CASE # C15-2014-0050

**CITY OF AUSTIN**  
**APPLICATION TO BOARD OF ADJUSTMENT**  
**GENERAL VARIANCE/PARKING VARIANCE**

STREET ADDRESS: 1193,1191,1195,1197,1199 Waller Street 78702

CITY OF AUSTIN – PLANNING AND DEVELOPMENT REVIEW DEPARTMENT  
RESIDENTIAL PLAN REVIEW APPLICATION – MASTER COMMENT REPORT

## Residential Zoning Review - Paul Yadro - 512-974-3553

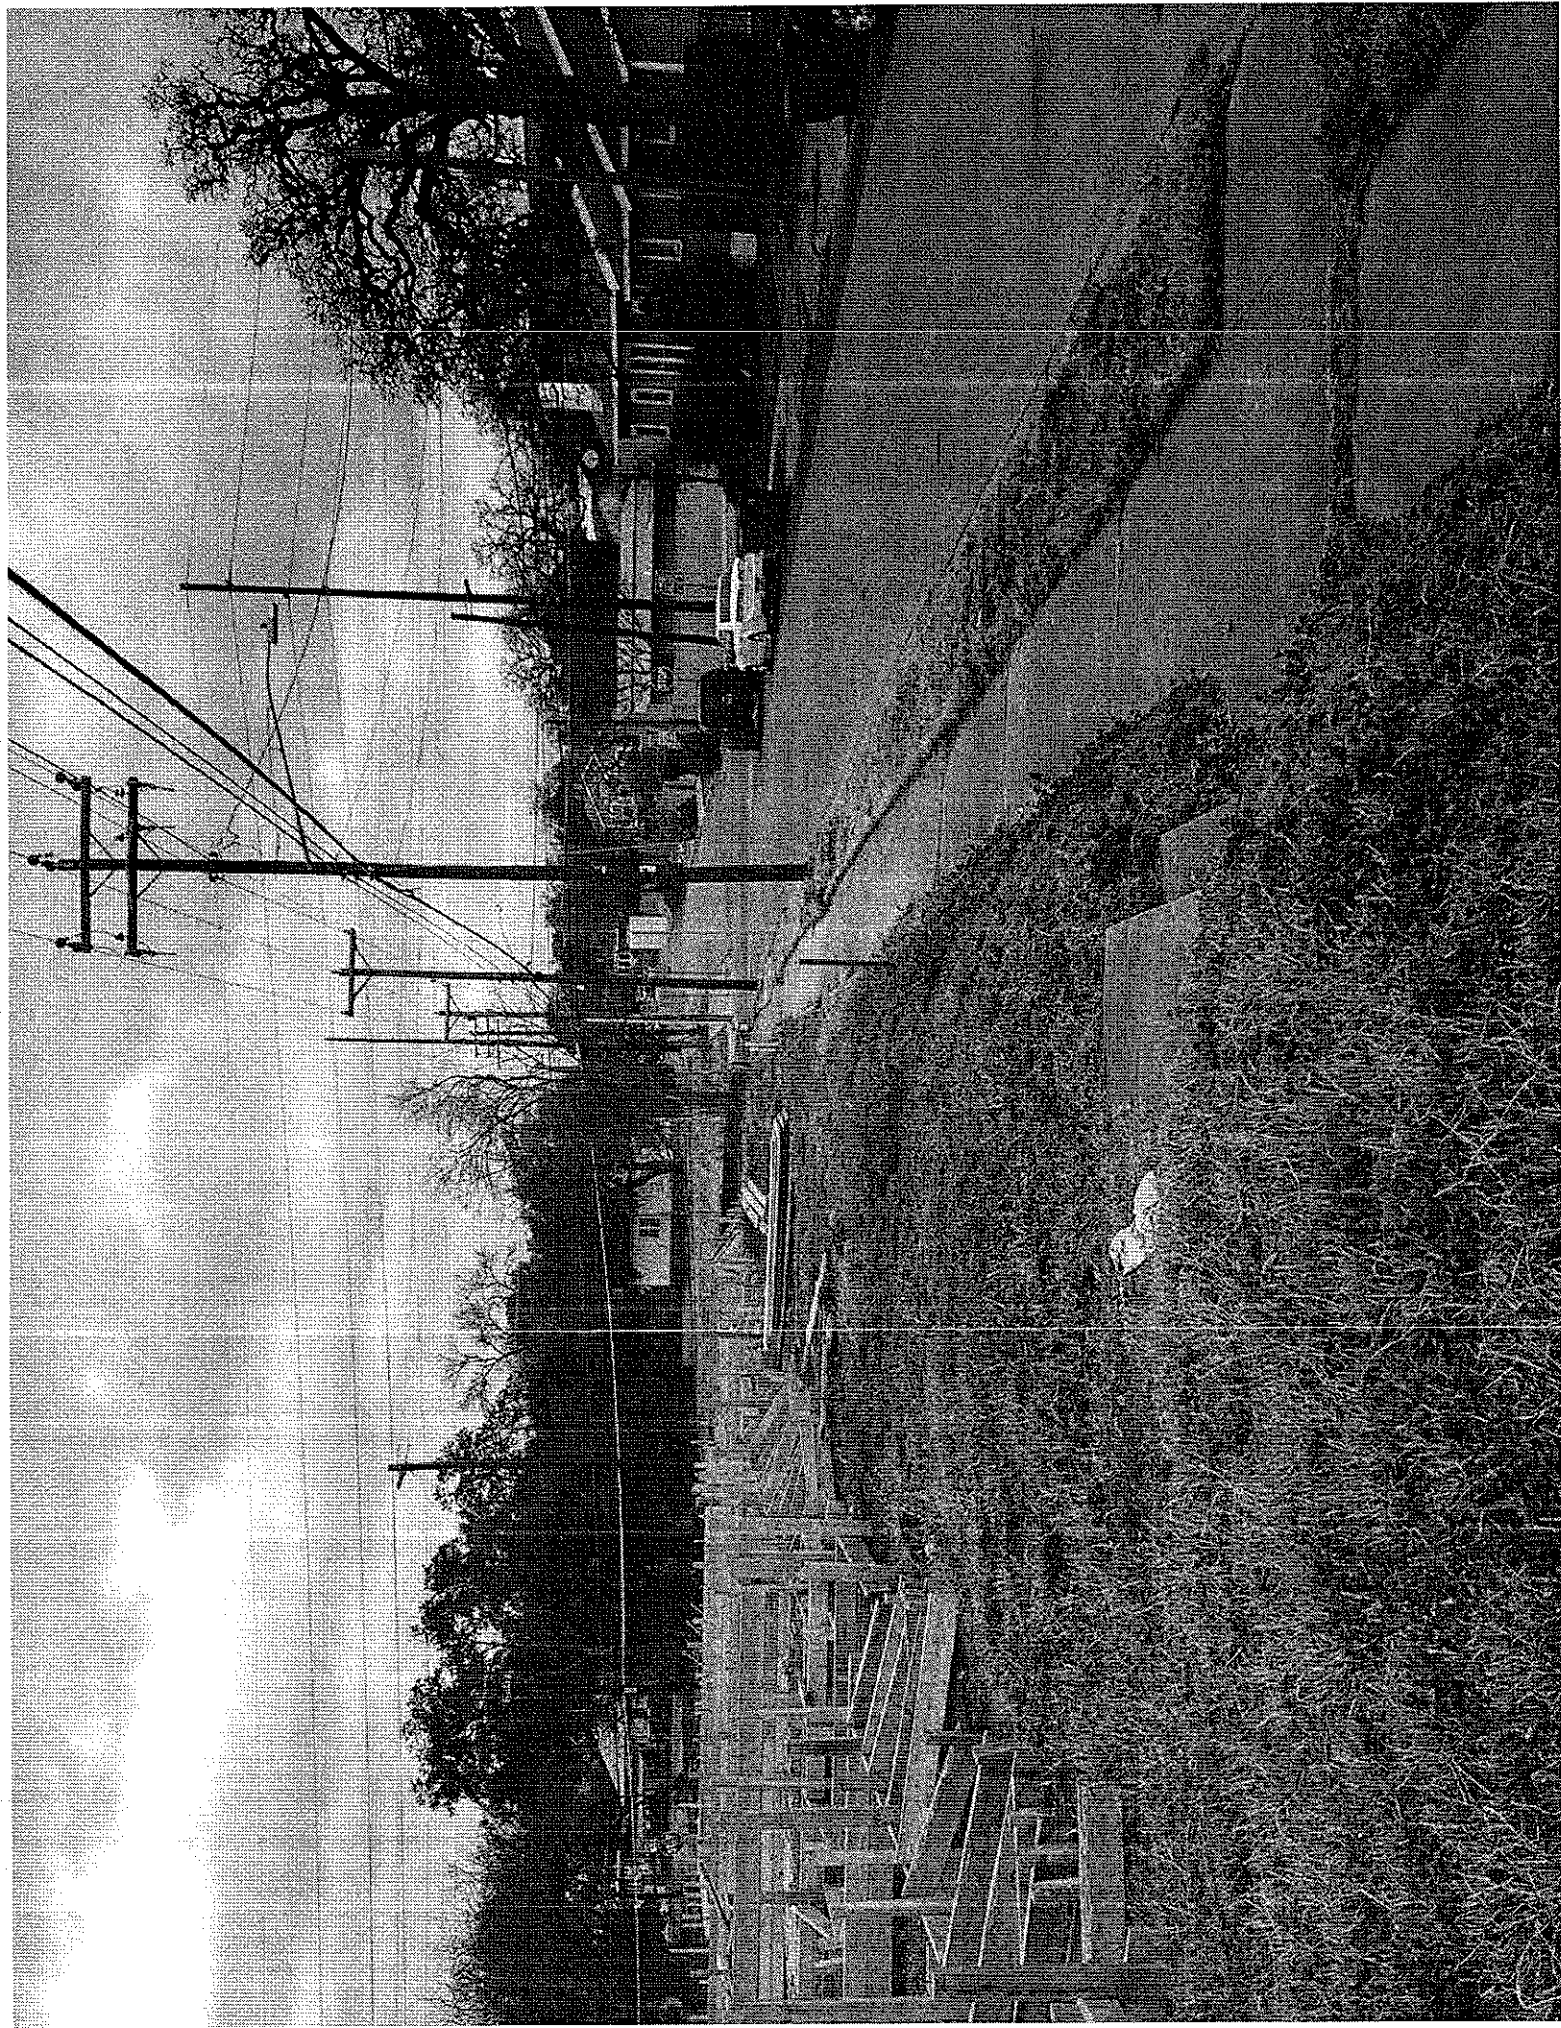
- ① Subject property is a through lot and per LDC 25-1-21<sup>5</sup>-515 – the rear yard setback is the same as the front yard setback. In addition, per LDC 25-1-21 (41) - a front line for a through lot is the lot line abutting the street that provides the primary access to the lot. The setbacks for this property are 15 feet for both the front and rear yard setbacks, 10 feet for a street side yard setback, and 5 feet an interior side yard setback.

- ③ The plot plan submitted and proposed building footprint does not comply with the required setbacks for this property. The garage is encroaching into the front yard setback. Plans will have to be revised or the applicant must seek a Board of Adjustment Variance. 25-2-779

4. The property has multiple 10 feet easement (electric and telecom) lines along the property lines adjacent to the adjacent Right-of-Ways. The plot plan must be revised to correctly depict and label the existing 10 feet easements as platted and recorded with the Anderson Hill Subdivision.

5. No encroachments of structures (which includes eaves and roof overhangs) are allowed within the 10 feet (electric and telecom) easements on the subject property. Plans must be revised and approved by Austin Energy prior to Final Approval of this Plan Review.

7. Provide and label a benchmark (spot elevation) on the plot plan for reference.
8. On the plot plan provide the high and low elevations (values) adjacent to the grade of the structure (label them as high adjacent grade and low adjacent grade and include the elevation value) and provide the average adjacent grade (AAG) on the building elevations with its elevation value labeled.

- ⑨ On at least one building elevation depict the structure's maximum height per LDC – 25-1-21-47. Note: Max. Bldg. Height is limited to 35 feet for this structure.

## Site Plan

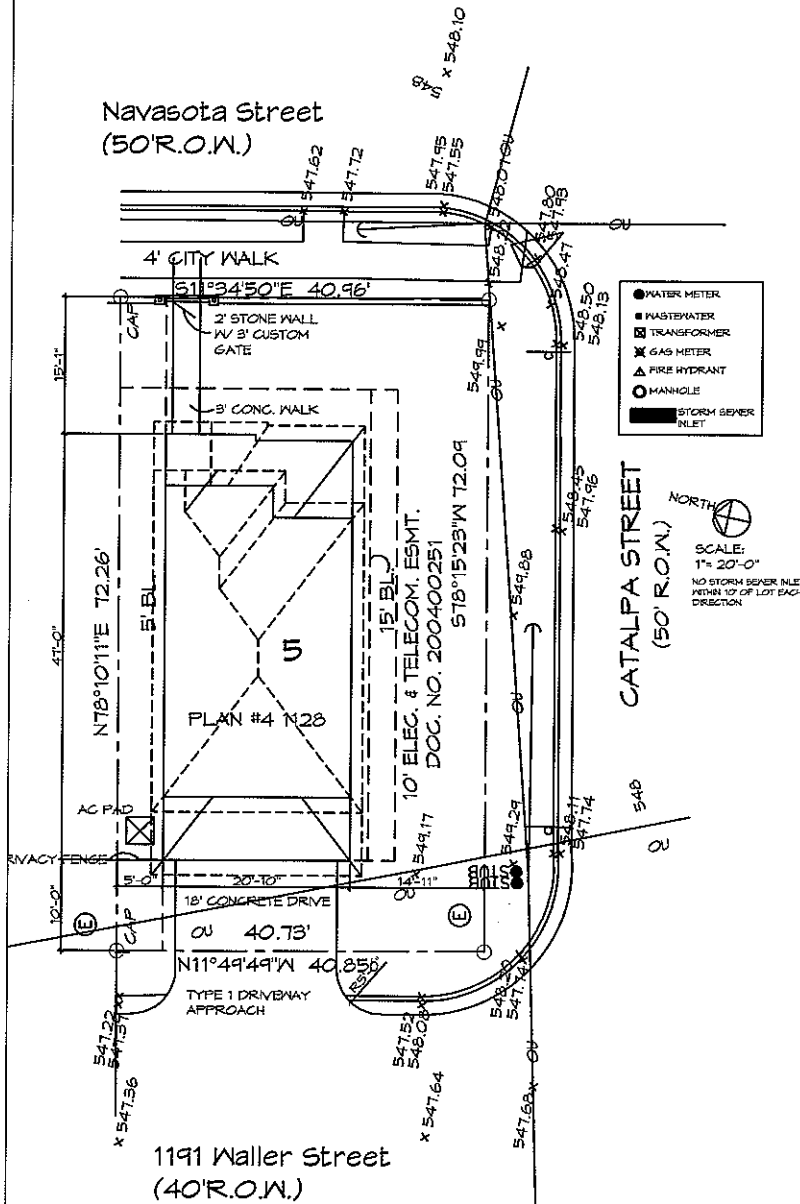
- 1) Building cover % for each lot – impervious cover is provided, but not building cover – maybe it's written elsewhere on a plan, but I can't find it on the lot/plan sheets. They'll ask about it if it's not shown, even if it wasn't a comment.
- 2) What is the impervious cover limit for each lot, I can see that they vary from 44-52%, but don't see what the limit is.
- 3) What street are the lots varying from (all are 15' to 10, but from Waller or Navasota).

To answer your questions below I've copied a chart showing the Building Coverage and the Impervious Cover percentages. Currently the addresses are on Waller Street but we are in the process of changing them to Navasota. You can see the new addresses below.

Lot	Block			IC		BC	
				IC Limit	Actual	BC Limit	Actual
1	B	1199 Waller	1198 Navasota	65%	48.35	60%	37.92
2	B	1197 Waller	1196 Navasota	65%	51.96	60%	43.15
3	B	1195 Waller	1194 Navasota	65%	52.07	60%	43.24
4	B	1193 Waller	1192 Navasota	45%	44.6	40%	38.2
5	B	1191 Waller	1190 Navasota	45%	44.09	40%	32.9

15' Front Building line on Navasota

10' to Rear of the house (Rear Garage) on Waller

Currently a 10' Elec. And Telecom easement on Waller that dictates the 10' setback to slab

5' Rear Yard is reqmt. Per zoning
